Planning Commission Hearing Date: March 3, 2026
Board of Commissioners Hearing Date: March 26, 2026

STAFF ANALYSIS

CASE NO.:	Z-26-1247923	File ID #: 2026-0139
Address:	3003 Chamblee-Tucker Road; 2936 Mercer University Dr. Chamblee, GA 30341	Commission District: 1 Super District: 7
Parcel ID(s):	18 283 04 001; 18 266 05 014	
Request:	Application of Urbanvue Apartments c/o Battle Law, P.C. to rezone property from O-I (Office-Institutional) zoning district to MR-2 (Medium Density Residential-2) zoning district to allow a townhome community.	
Property Owner(s):	Urbanvue Apartments, LLC.	
Applicant/Agent:	Urbanvue Apartments, LLC. c/o Battle Law, P.C.	
Acreage:	5.44	
Existing Land Use:	Regional Center	
Surrounding Properties:	North: O-I (Office-Institutional), R-100 (Residential Medium Lot-100) South: O-I East: R-100 West: O-I, NS (Neighborhood Shopping)	
Comprehensive Plan:	Regional Center	Consistent X Inconsistent

STAFF RECOMMENDATION: One Cycle Deferral.

CONCEPTUAL SITE PLAN
3003 CHAMBLEE TUCKER ROAD
CHAMBLEE, GA 30341
JURISDICTION: DEKALB COUNTY
URBANVUE APARTMENTS, LLC

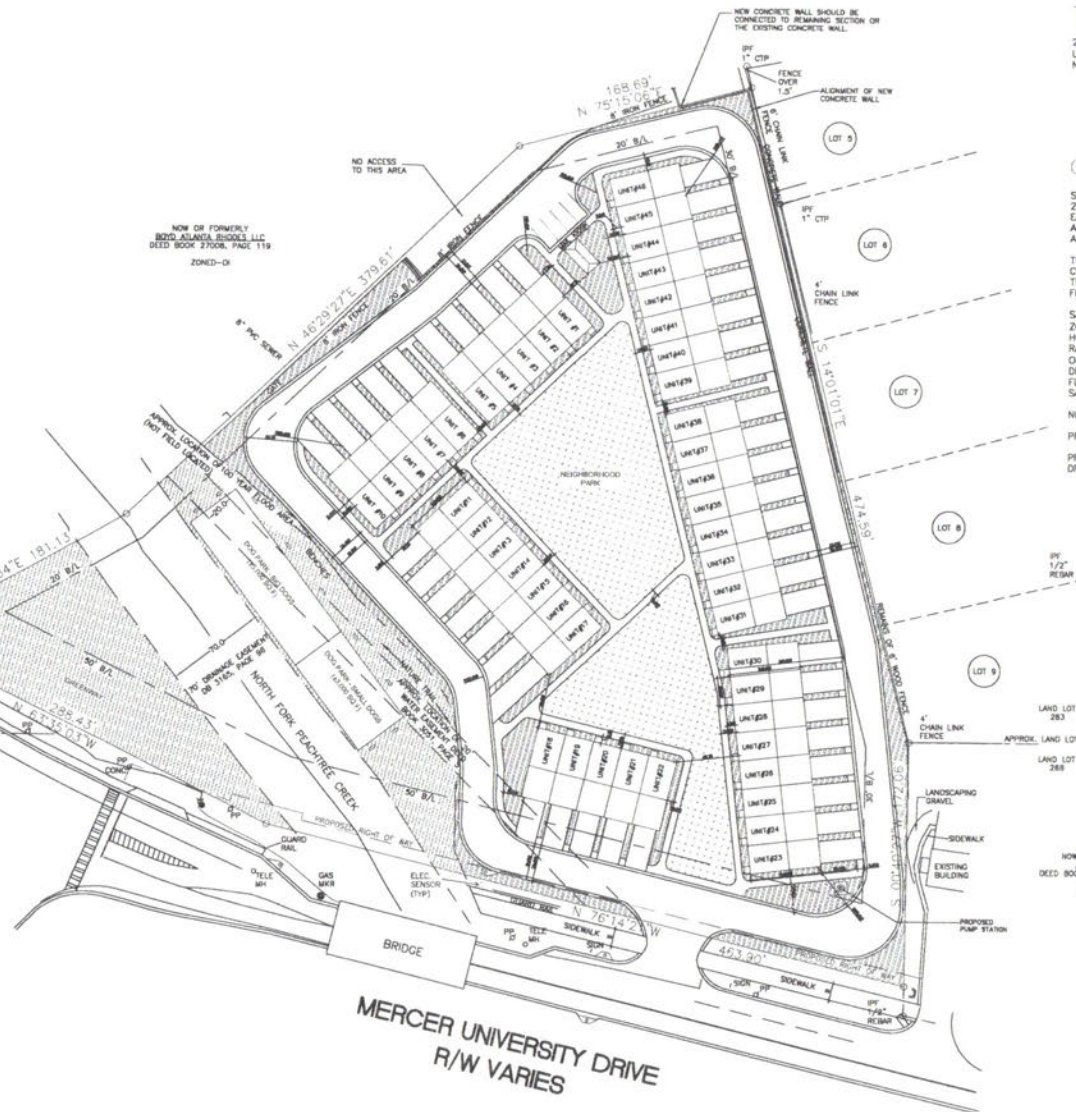
Based on the current layout, Staff has discussed concerns with the applicant that the proposed density may exceed what the site can reasonably accommodate. The site constraints include a stream buffer on the west boundary line of the property, and a fifty (50) foot buffer along the eastern boundary line of the adjacent properties (R-100). A variance from the Zoning Board of Appeals (ZBA) will be required to decrease the buffer to thirty (30) feet, as shown on the site plan (*Conceptual Site Plan A100*). The purpose of MR-2 zoning districts is to provide connectivity of streets and communities, increase the ease of movement in and around new developments, and allow appropriate transitions between existing and new developments. The proposal mostly satisfies the minimum dimensional requirements of MR-2. However, an alternative site plan design appears necessary to align the proposal with MR-2 standards and the RC (Regional Center) character area. The following improvements have been discussed with the applicant:

- Inter-parcel connection with the vacant FEMA parking lot to the north (offers additional access point)
- Dead-end road ("hammerhead") conditions at the site entrance.

- Unit re-configuration; block creation, pocket parks, and rear loading garages.
- Opportunity to remove two (2) dog parks and continue an alley along the western property line (outside the stream buffer) to eliminate the “hammerhead” road configuration at the entrance via a looped road or inter-parcel connection.

Underground detention would work best for this property. it can't be in the stream buffer or flood plain

There is both flood hazard and state water. 25 and 75 foot buffer will apply. There is no building allowed in the floodway

COMMENTS: Both parcels in this rezoning application have floodplain and regulated floodway
which must be preserved and protected under the county's flood damage
prevention ordinance.
